RE: Staff Report – Tractor Supply Commercial Corridor Overlay Variances

Tractor Supply has submitted an application for relief from the commercial corridor overlay standards listed below for a total of 13 variances. Numbers 1 through 4 of this report are related to siteplan and landscape plan variances while 5 through 11 are related to building materials variances.

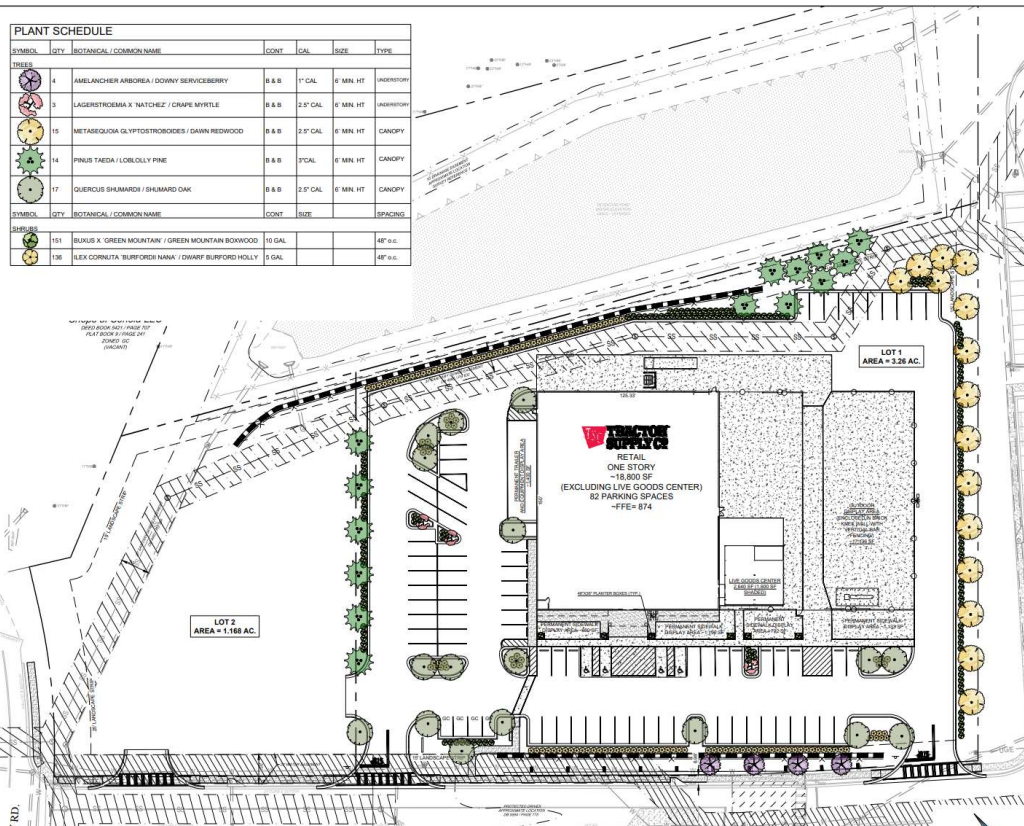
- a. Reduce the required landscape buffer along the internal roadway from 20 feet to 15 feet.
- b. Reduce required landscape buffer along western property line between Tractor Supply and adjacent out parcel from 15 feet to 7.5 feet with both sides installing 7.5 feet on their side of the line for an overall width of the landscape strip between out parcels at 15 feet.

Staff conducted an audit of the width of installed landscape buffers within the shopping center and found the landscaping widths installed to be inconsistent with the required width of buffers per ordinance.

The average width of landscaping installed along the private internal roadway was found to be 16 feet with the smallest width measuring only 5.4 feet. The average width of landscaping between parcels was 25 feet however not centered upon the property lines as in the case between Chick-Fil-A and Piedmont where landscaping is all on one side of the line.

Therefore approval of both requested variances will be consistent with what has been installed/approved within the shopping center to date and will not negatively impact the surrounding tracts. The image below demonstrates the inconsistent landscape widths for reference.

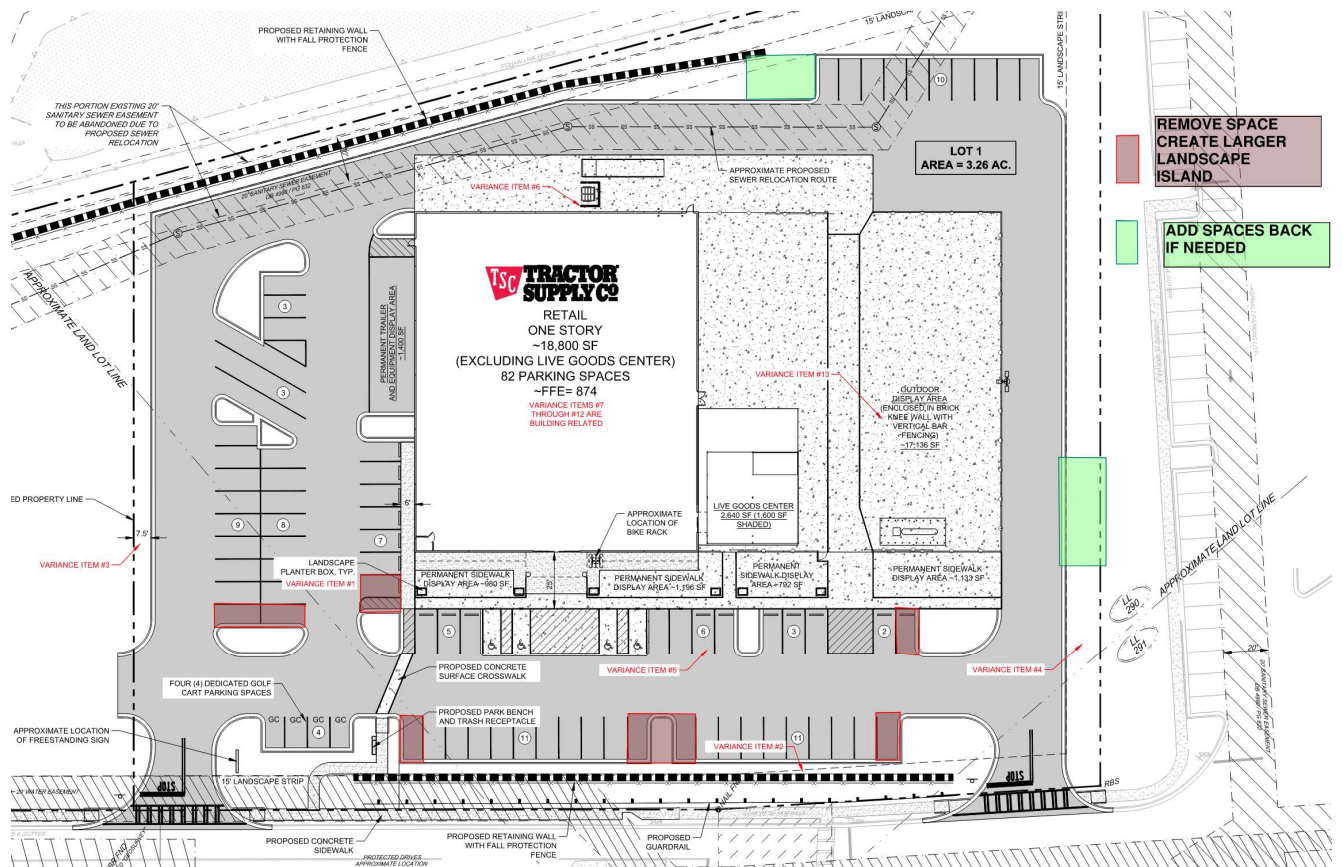
The image below shows the parking layout and indicates areas where parking spaces could be removed and landscape islands enlarged shown in red. The green areas are locations where possible parking could be added back to achieve the 50% maximum parking in FRONT.

4. Section 74-199 – Reduce amount of greenspace required from 20% to 17%

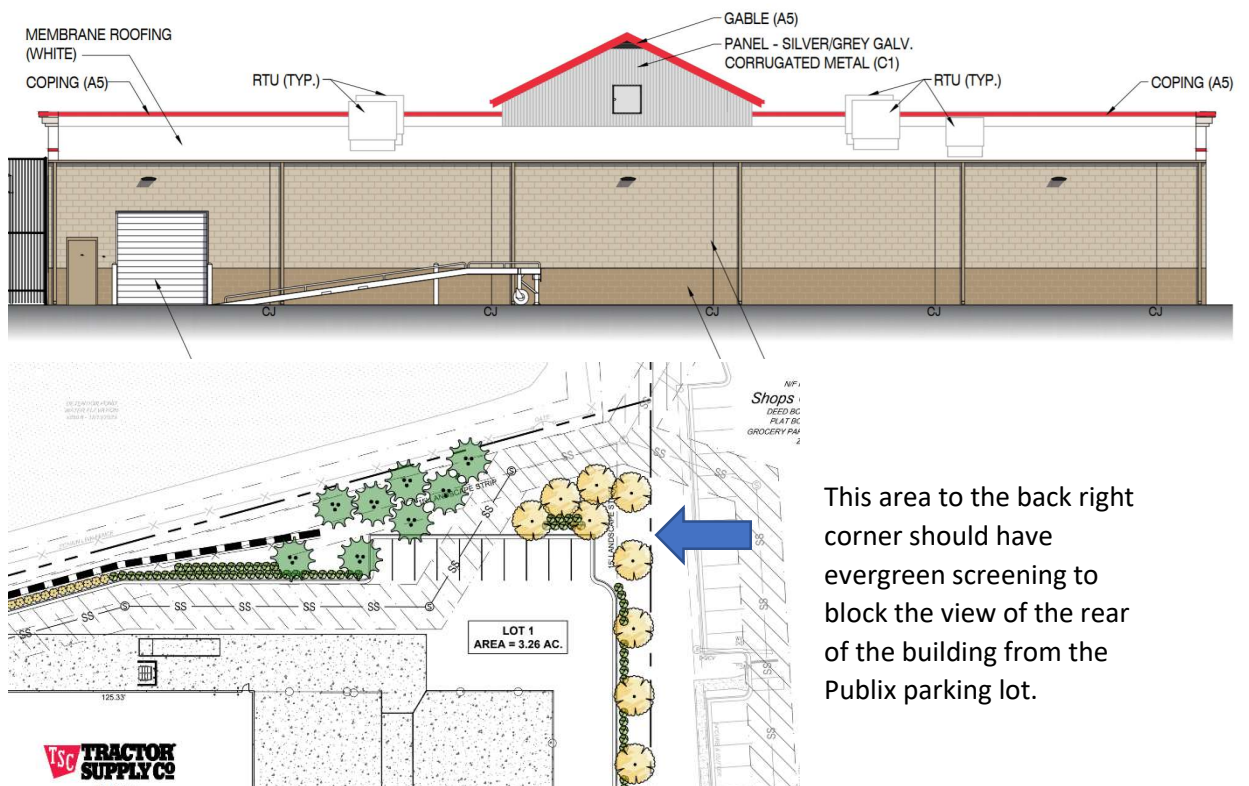
The applicant is requesting to provide 3% less greenspace while still providing a fully landscaped site. The site layout as presented is what is needed for parking, storage, and vehicle circulation per Tractor Supply. If additional greenspace is provided, then either the size of the out parcel will be reduced or less parking provided and Tractor Supply contends that as presented the proposed parking (81 spaces) is needed. Allowing a reduction of greenspace will also allow the out parcel to be larger and similar in size to the other out

parcels within the development. Approval of this variance will not negatively impact the surrounding tracts.

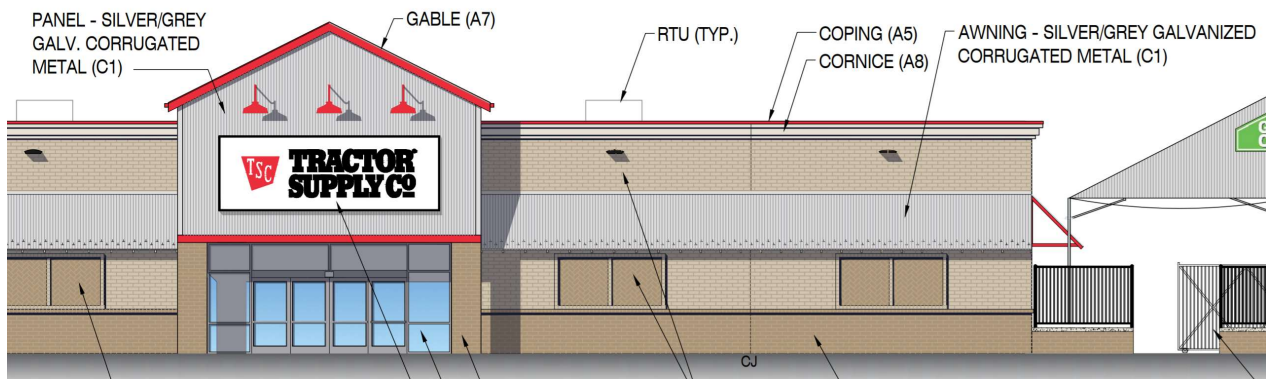
- 5. Section 74-188 (a)[3](c) – to allow the rear façade of the building to be a finish of smooth faced block painted to match the color and pattern of the brick versus brick as proposed on the other three sides.

Approval of this variance is consistent with what was previously approved for Publix and the rear façade will not be visible from adjacent tracts or the internal roadway but a portion of it

will be visible from the adjacent parking areas on the west side of Publix near the pharmacy drive thru. Although it will be visible from this area, it will be painted to match the brick so it will blend and additionally the view from Publix parking area will be mitigated by landscaping in the back right corner.

This area to the back right corner should have evergreen screening to block the view of the rear of the building from the Publix parking lot.

If approved, consider requiring evergreen trees in the back right landscape buffer to provide year round screening of the back of the building from the adjacent parking area near Publix pharmacy drive-thru.

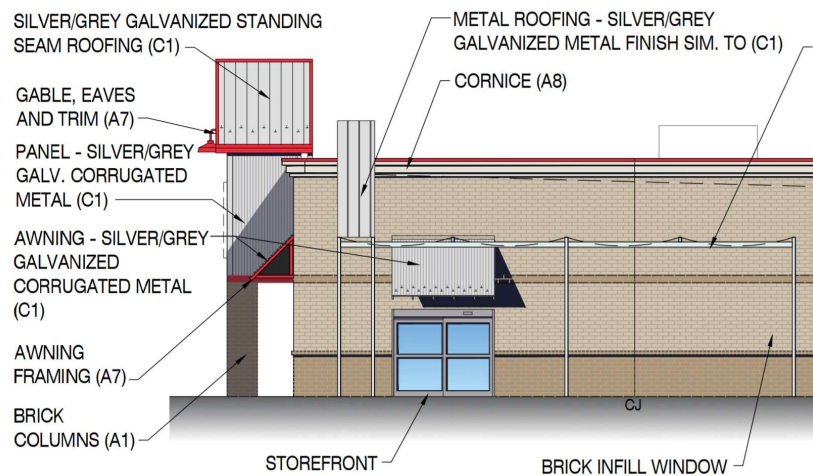
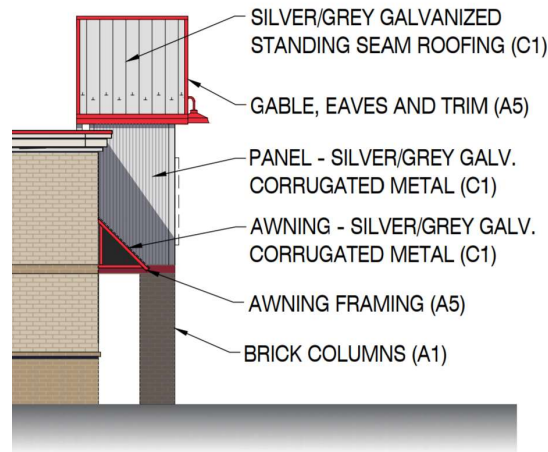
6. Section 74-198 – to waive the requirement that the dumpster enclosure materials be brick, stone, or stucco and allow to match the rear façade proposed to be painted smooth block, which is variance in number 5 above.

If variance number 5 above is approved then this variance should also be considered for approval. The dumpster enclosure is proposed as smooth block walls painted to match the primary structure which will match the building material for the back wall if variance number 5 is approved. Again the dumpster will only be visible from the Publix parking areas near the pharmacy drive thru and can be mitigated with landscaping to screen the view. Approval of this variance will not negatively impact the surrounding tracts.

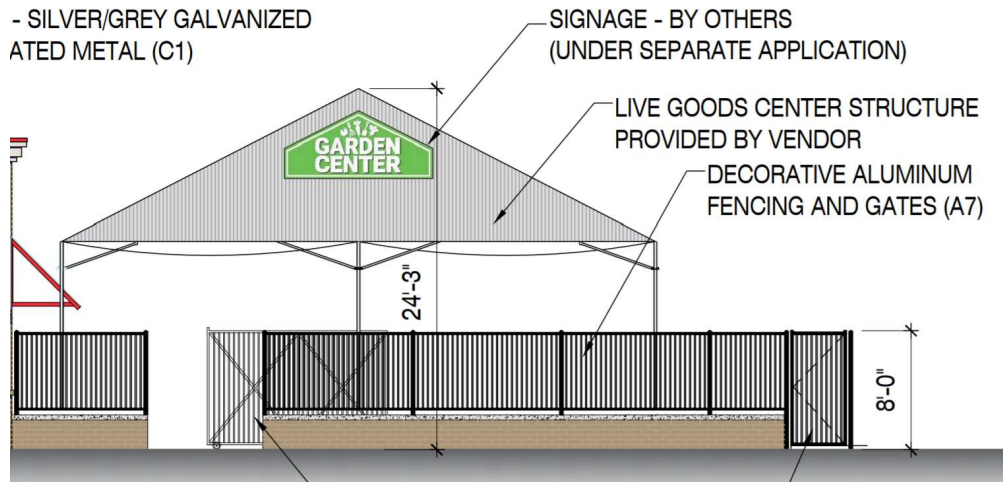
- a. To allow the use of heavy gauge corrugated metal panels on the front and side façade entry tower and awnings.
- b. To exceed 10% in accent material on the front façade for EFIS cornices and metal on entry tower and awnings.

The use of corrugated metal panels on the entry tower and garden canopy, standing seam metal roof for roof for the entry tower and garden canopy, and the corrugated metal awnings are all corporate brand finish associated with all Tractor Supply stores. The overlay only allows brick, stone and stucco and specifically excludes these materials listed above. The corrugated metal panels are galvanized heavy gauge metal not aluminum or plastic.

The use of the metal awnings on the front façade will require an additional variances since the combination of EFIS and metal accent will exceed 10%. Approval of these requested variances for materials will not negatively impact the surrounding tracts.

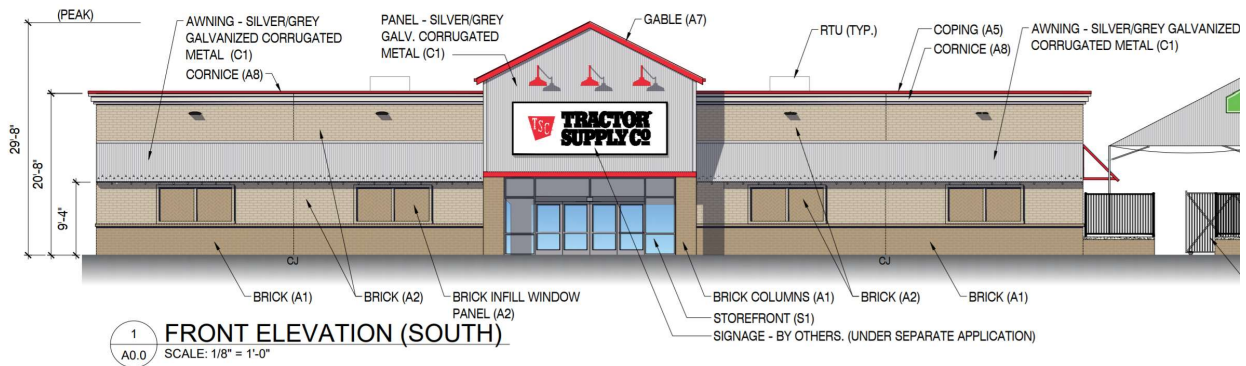
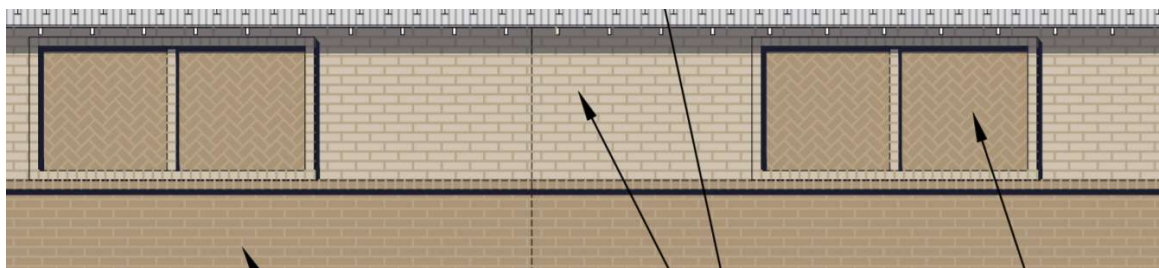
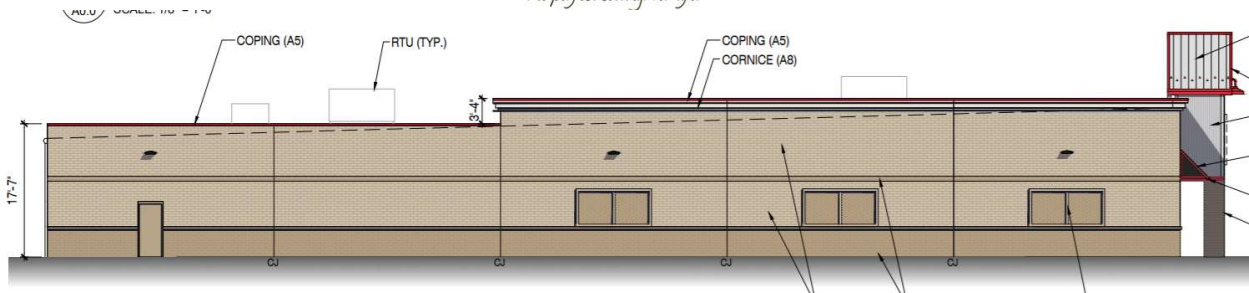
- 10. Section 74-188 (a)[3](g) – to waive the required minimum percentage of windows on the primary and secondary facades and allow the windowless walls. For the sides visible to the parking areas and internal roadway the applicant is proposing decorative faux windows with the brick pattern as mitigation for not providing real windows.

The overlay requires 60% windows for storefronts and does not allow blank windowless walls on the primary or secondary facades. The front and both sides of the building will need a variance from this section. Applicant has proposed the use of "faux windows" in the brick pattern on the front and both sides. Approval of this variance is consistent with recent variances granted will not negatively impact the surrounding tracts.

4 RIGHT SIDE ELEVATION (EAST)
A.0.0 SCALE: 1/8" = 1'-0"

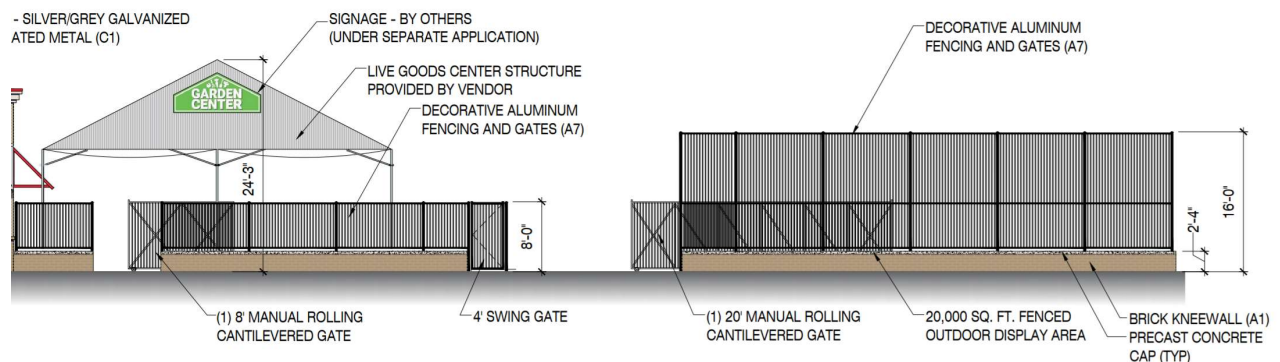
- Section 74-195 (a) - to allow unenclosed outside storage in the FOD area to be enclosed with an ornamental "wrought iron look" aluminum fence and brick knee wall instead of a full height brick wall on the front and side façade and to allow the FOD area to only have ornamental fencing on rear façade with no knee wall.

The proposed decorative aluminum fence with brick knee wall (front and side) will meet the intent of the ordinance for screening the outdoor display area and also the needs of Tractor Supply to provide security for items stored within this area. Approval of this variance will not negatively impact the surrounding tracts.
